◀ IMPORTANT UPDATE ▶

Original Publication Date: September 7, 2018

SAFETY RECALL JOT (Remedy Notice)**Certain 2016 – 2018 Model Year Prius
Engine Wire Harness
NHTSA Recall No. 18V-579**

Remedy Procedures

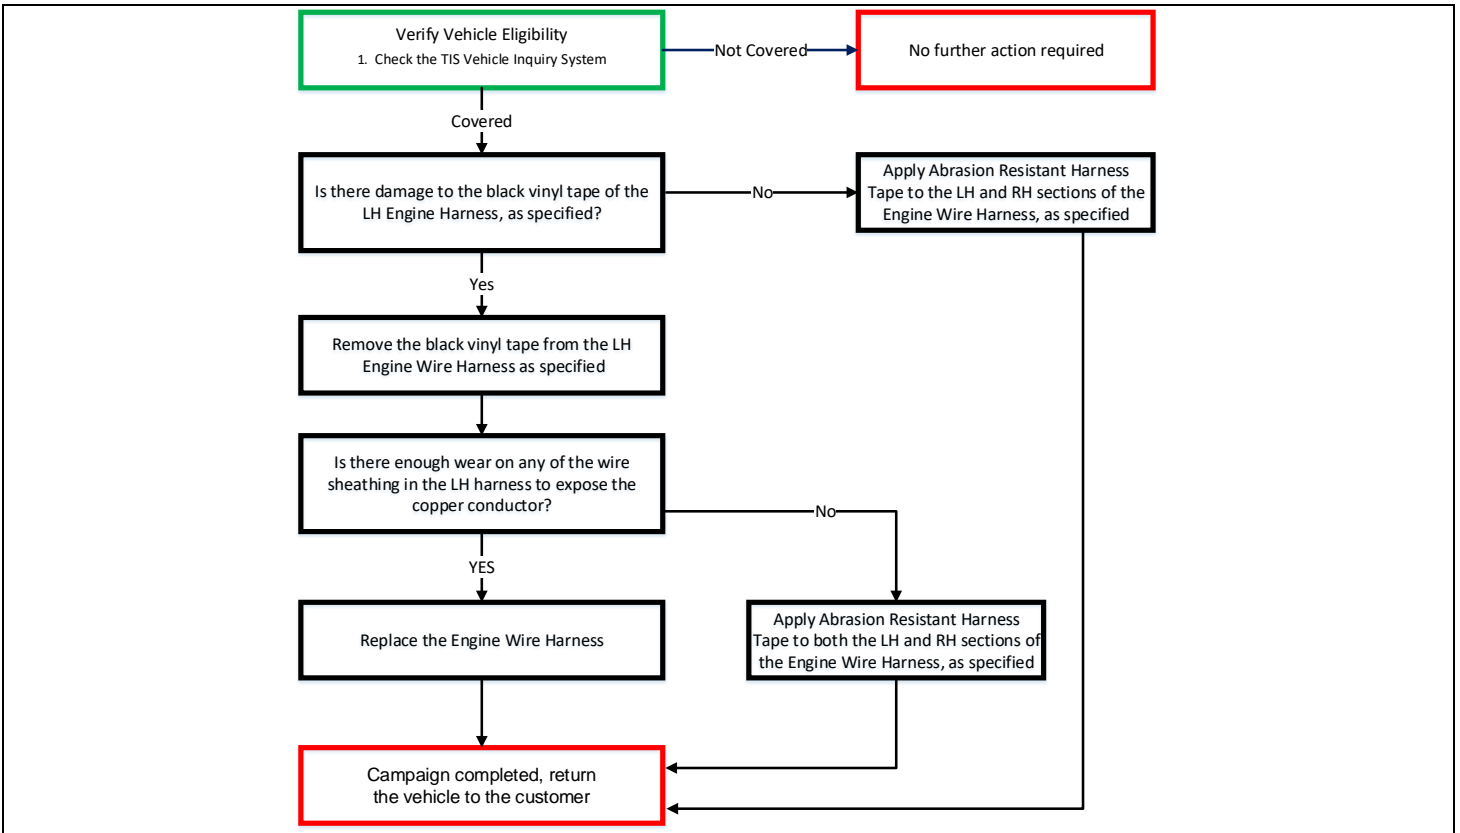
DATE	TOPIC
March 15, 2019	Information about additional rolls of protective tape from Toyota has been added to the Dealer Letter.
November 15, 2018	<p><i>Effective November 15, 2018, the remedy procedure has been updated. Dealers should refer to the updated Technical Instructions and Dealer Letter on TIS.</i></p> <p>All vehicles that have not already had JOT completed should receive the updated remedy procedure.</p> <p><u>Updates to this Dealer Letter:</u></p> <ul style="list-style-type: none">• The flow chart has been updated.• The warranty reimbursement procedure has been updated.

Refer to TIS for Technical Instructions on repair. Conduct all non-completed Safety Recalls and Service Campaigns on the vehicle during the time of appointment.
